# UNITED STATES PATENT AND TRADEMARK OFFICE

APPLICATION NO.	FILING DATE	FIRST NAMED INVENTOR	ATTORNEY DOCKET NO.	CONFIRMATION NO.
10/629,674	07/30/2003	Johannes Menzel	A 91755	6480

**Office Action Summary**

## **DETAILED ACTION**

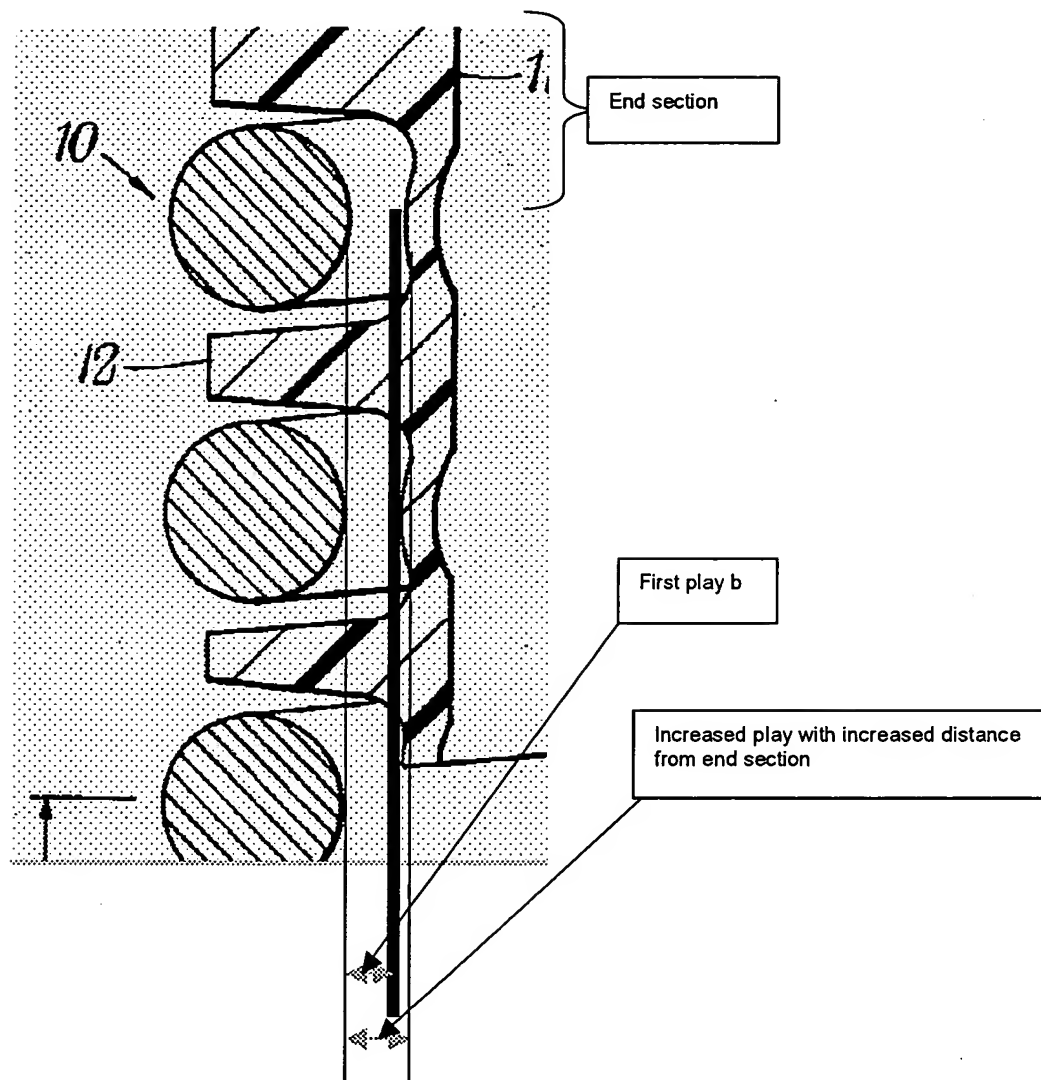
Re: claims 3, 17, 18 and 19. Clarke et al. show in the figure an antivibration element comprising: a coil spring 10 subject to deformation under load during operation of the antivibration element, the coil spring defining a longitudinal axis and having an end section, a midsection, and a transition section extending from the end section to the remainder, a guide member 12 having a helically shaped guide slot wherein turns of the coil spring are guided, the end section and the transition section being guided in the guide slot, the end section being fixed in the guide slot, the helically shaped guide slot having a base and the transition section being guided in the guide slot with a first play to the base measured in radial direction as shown, the guide slot having first and second

Re: claims 6 and 7. Clarke et al. show in the figure the limitation wherein the coil spring has first and second ends (radial ends – one radial end shown at the radially outermost section of the right top coil and the other radial end shown at the radially outermost section of the left bottom coil) twisted relative to each other by approximately a half turn.

Re: claim 12. Clarke et al., as modified, show in the figure of Clarke et al. the spacing of the base of the guide slots to the longitudinal center axis becoming less with increasing distance from the end section from the bulge of the base down to the tapered portion of the base.

Examiner notes that Clarke et al. show in the labeled version of the figure above the limitation of a first play b increasing with increasing distance from the end section towards a transition section to a certain extent (note the second pair of double arrows labeled increased play with increased distance from end section).
